BUQUET BRIDGE OVER GRAND CAILLOU HURRICANE IDA REPAIRS

Addendum # 2

Subject: TPCG Hurricane Ida Recovery
Purpose: Addendum 2
Today's Date: 10/29/24

COUNTERWEIGHT ROPES
 DETAILS (CONTINUED)

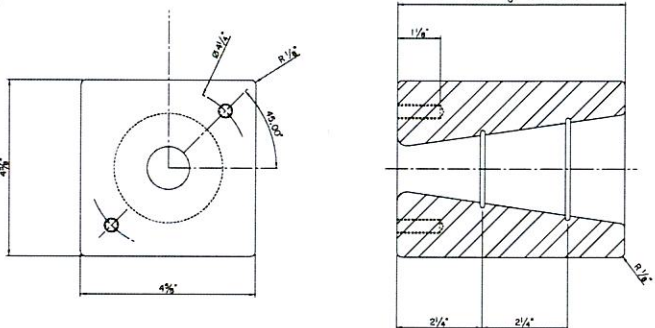
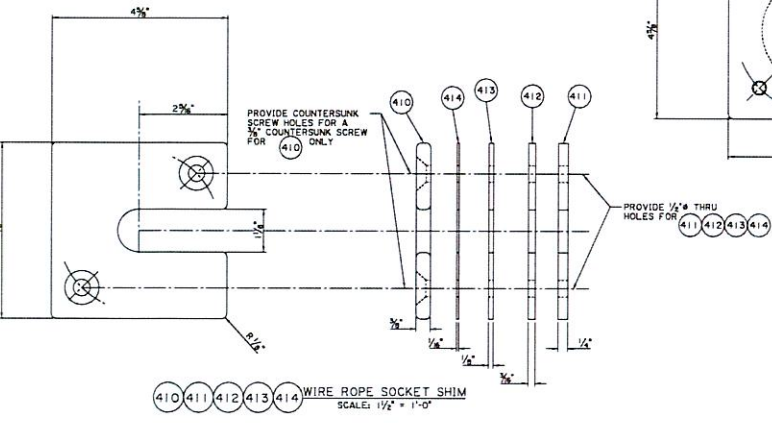
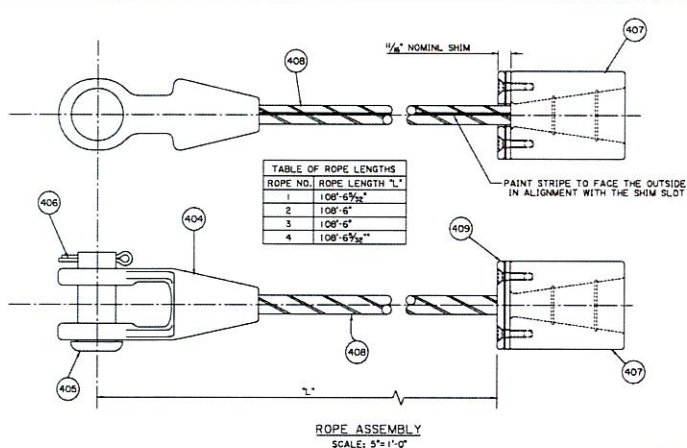
Question: The socket shims have a throat opening of 1-1/8". As just stated above, with the standard rope tolerance, these shims won't fit well, if at all. Can we open this up to 1-1/4"? (if the first question changes the wire rope to 1", it can be left at 1-1/8")

Answer: Because the ropes are to be 1" diameter the socket shims don't need to change.
